CITY OF ALBUQUERQUE

PLANNING DEPARTMENT – Development Review Services

RE: Anasazi Ridge, Unit 3 (File: A10D002G)
Drainage Report, Engineer's Stamp Date 1-12-2015
Supplemental Rundown Calculations, Engineer's Stamp Date 2-3-2015
Grading and Drainage Plan Engineer's Stamp Date 3-4-2015

**Re: Anasazi Ridge Unit 3
Revised Engineers stamp date 3-4-15 (A10 / D002G)**

SPILLWAY & CONCRETE CHANNEL DETAIL - TRACT A
SCALE: 1"=5'
(CHANNEL CONSTRUCTION AT DRC PER C.O.A. STD. DWG #2260)

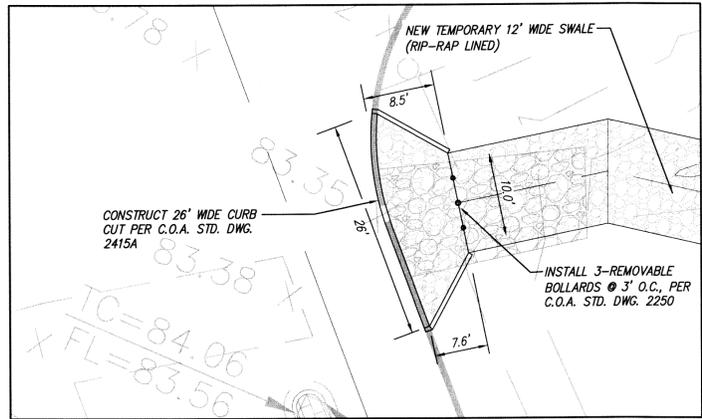
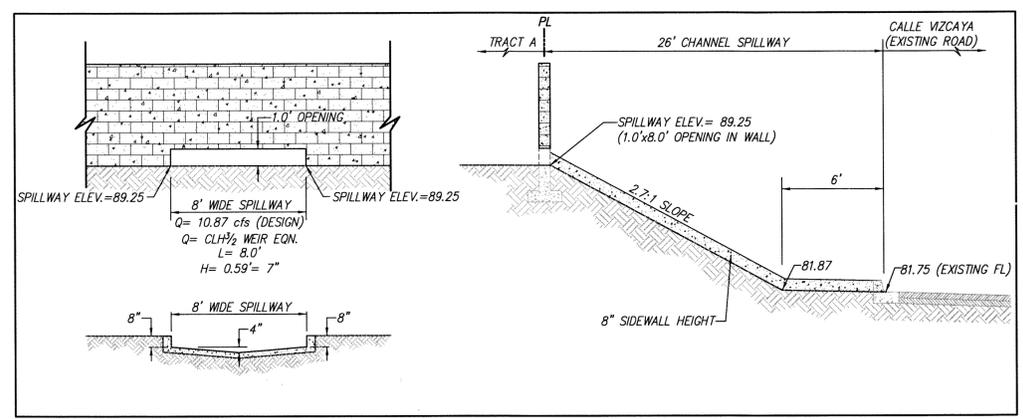
- It is understood that Tract A, B, and C have been incorporated into the adjacent lots. Remove the Tract labels on the Engineer's Certification plan.
- Ponds and channel sections in the public drainage easements on lots 23-P1 and 16-P1 need to be included in the Work Order Construction set.

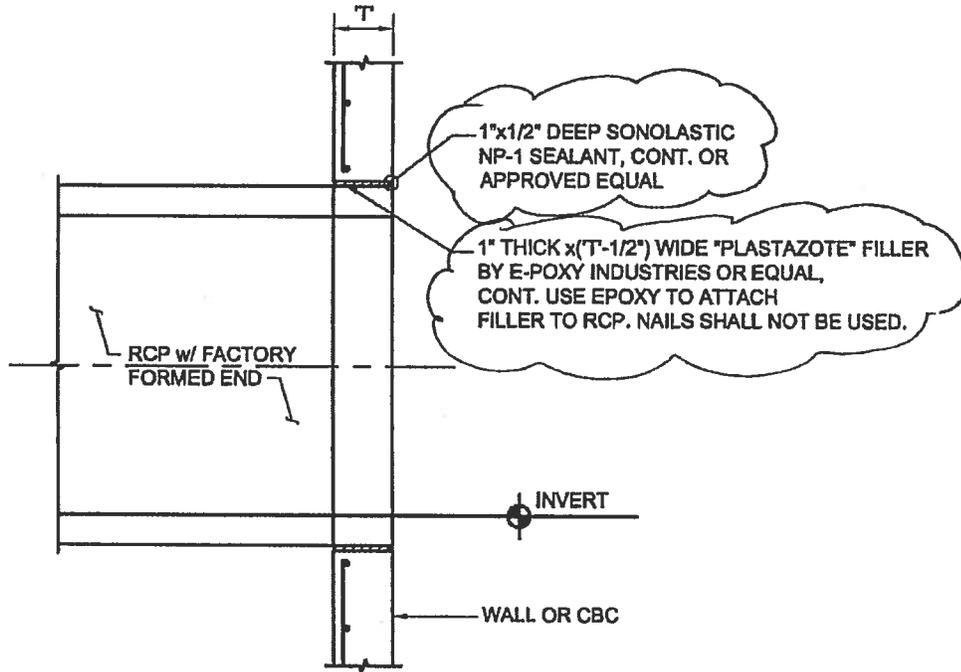
5. The expansion joint on the Drainage Channel Connection Detail is not approved by AMAFCA. The connection will be similar to AMAFCA's standard detail for a pipe penetration through a wall. See attached detail. The Plastazote filler will run the entire length of the connection with NP-1 sealant at both ends.

6. AMAFCA will require a removable trash screen close to the removable bollards to collect large debris before it flows into the arroyo. See attached detail.
